183rd session

Proposal for Supplement 2 to the 01 series of amendments to UN Regulation No. 152 (AEBS for M₁ and N₁)

Submitted by the Working Party on Automated/Autonomous and Connected Vehicles *

Figure 1
Left turn or right turn at the intersection

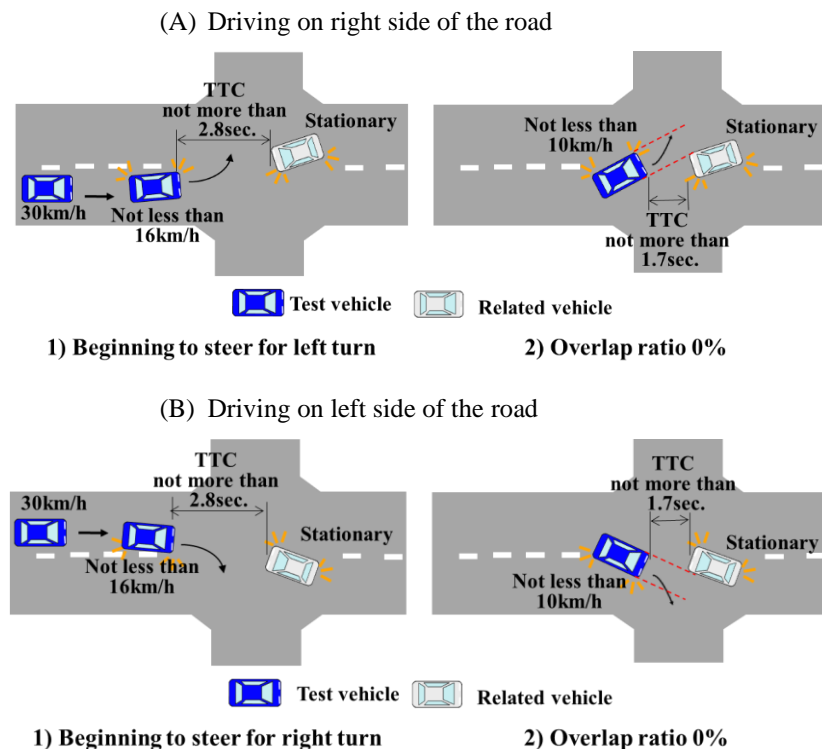
Insert new Scenarios 1 to 4, to read:

Left turn or Right turn at the intersection

- 1.1. In this scenario, the subject vehicle passes by a left turn or right turn in front of an oncoming vehicle that is stopped to make a left turn or right turn at an intersection.
- 1.2. An example of the detail scenario:
 The subject vehicle drives at a speed of 30 km/h (with a tolerance of +0/-2 km/h) toward the intersection, and decelerates by braking to a speed of not less than 16 km/h at a point where the subject vehicle begins to steer left / right, and the Time To Collision (TTC) to the oncoming vehicle is not more than 2.8 seconds. When the subject vehicle turns left or right in the intersection, the speed is reduced to not less than 10 km/h, and then drives at a constant speed. The TTC to the oncoming vehicle is not more than 1.7 seconds at when the overlap ratio between the subject vehicle and the oncoming vehicle becomes 0 per cent.

Figure 2

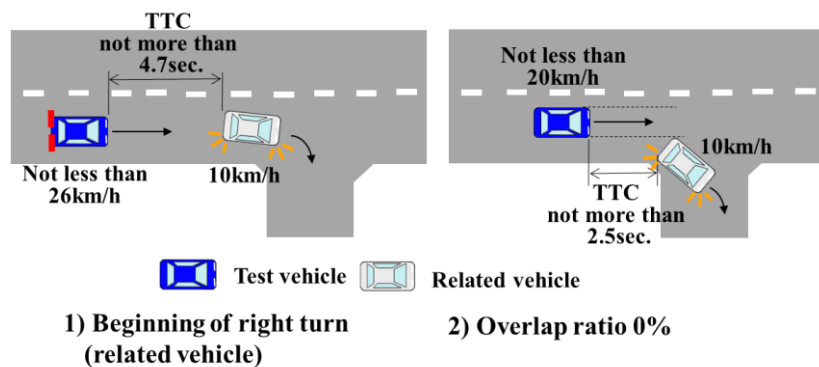
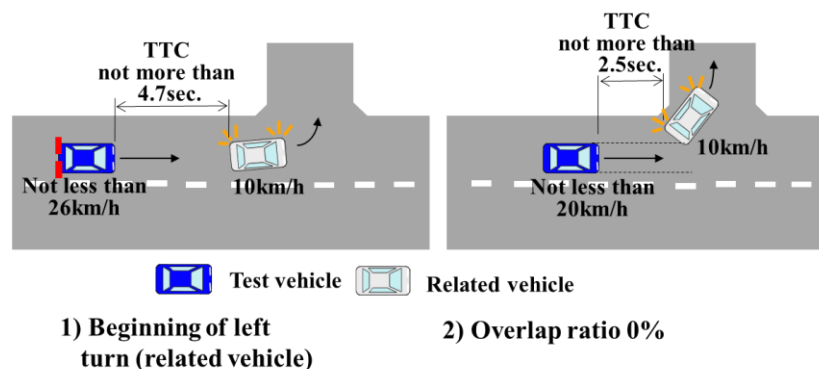
Right turn or Left turn of a forward vehicle

- 2.1. In this scenario, the subject vehicle follows a forward vehicle. After that, the forward vehicle turns right or left at a corner, and the subject vehicle goes straight.

- 2.2. An example of the detail scenario:
- Both the forward vehicle and the subject vehicle drive at a speed of 40 km/h (with a tolerance of +0/-2 km/h) on the straight road. The forward vehicle decelerates by braking to a speed of 10 km/h (with a tolerance of +0/-2 km/h) in order to turn right or left at the corner, and the subject vehicle also decelerates by braking to keep appropriate distance with the forward vehicle. At when the forward vehicle begins to turn right or left, the speed of the subject vehicle is not less than 26 km/h and the TTC to the frontal vehicle is not more than 4.7 seconds. After that, the subject vehicle decelerates to a speed of not less than 20 km/h, and then drives at a constant speed. The TTC to the forward vehicle is not more than 2.5 seconds at when the overlap ratio between the subject vehicle and the forward vehicle becomes 0 per cent.

Figure 3
Curved road with guard pipes and a stationary object

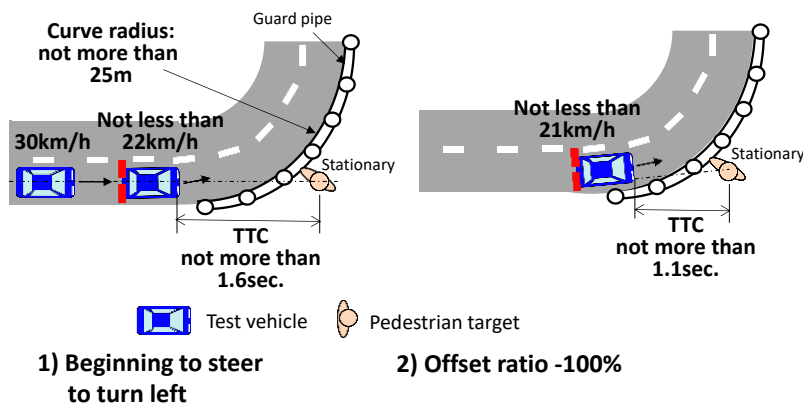
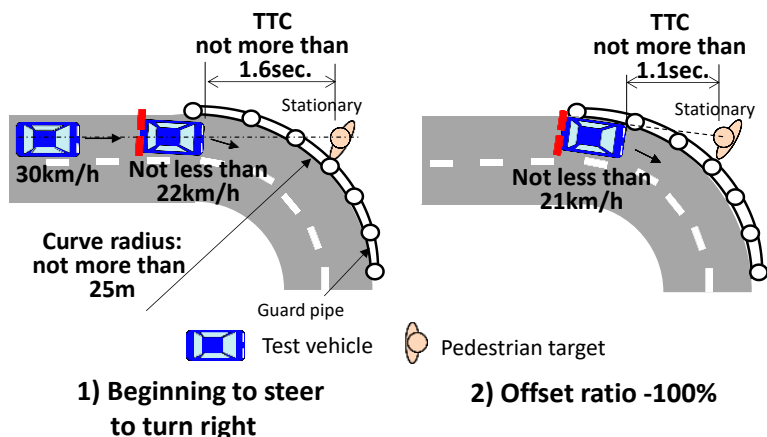
Curved road with guard pipes and a stationary object

- 3.1. In this scenario, the subject vehicle drives a small radius curved road of which the guard pipes are constructed to the outer side, and a stationary vehicle (M₁ category), a stationary pedestrian target or a stationary bicycle target is positioned just outside of the guard pipes and where on the extension of the centre of the lane.

- 3.2. An example of the detail scenario:
 The subject vehicle drives at a speed of 30 (with a tolerance of +0/-2 km/h) km/h toward the curve of which the radius is not more than 25 m at the outer side of the road, and decelerates by braking to a speed of not less than 22 km/h at a point where the subject vehicle enters the curve. The TTC to the stationary object is not more than 1.6 seconds at when the subject vehicle begins to turn in the curve. In the curve, the subject vehicle drives outer lane than the centre of the road. After that, the subject vehicle continue to turn in the curve at a constant speed of not less than 21 km/h. The TTC to the stationary object is not more than 1.1 second at when the overlap ratio between the subject vehicle and the stationary vehicle becomes 0 per cent, or at when the offset ratio between the subject vehicle and the centre of the stationary pedestrian target or the stationary bicycle target becomes -100 per cent.

Figure 4

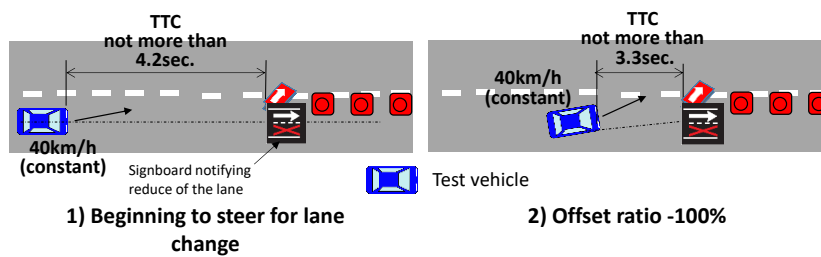
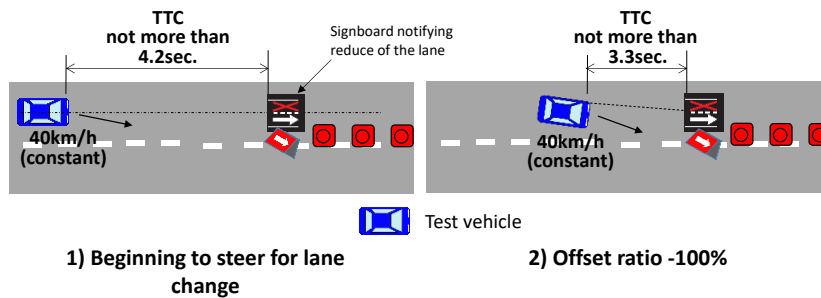
Lane change due to road construction

4.1. In this scenario, the subject vehicle changes the lane in front of the signboard which is positioned in the centre of the lane and notifies the driver that the lane is reduced.

The subject vehicle drives a straight road at a speed of 40 km/h (with a tolerance of ± 2 km/h) and begins to steer in order to change the lane in front of the signboard which notifies reducing the lane. No other vehicles approach the subject vehicle. The TTC to the signboard is not more than 4.2 seconds at when the subject vehicle begins to steer. During changing the lane, the speed of the subject vehicle is constant, and the TTC to the signboard is not more than 3.3 seconds at when the offset ratio between the subject vehicle and the centre of the signboard becomes -100 per cent.
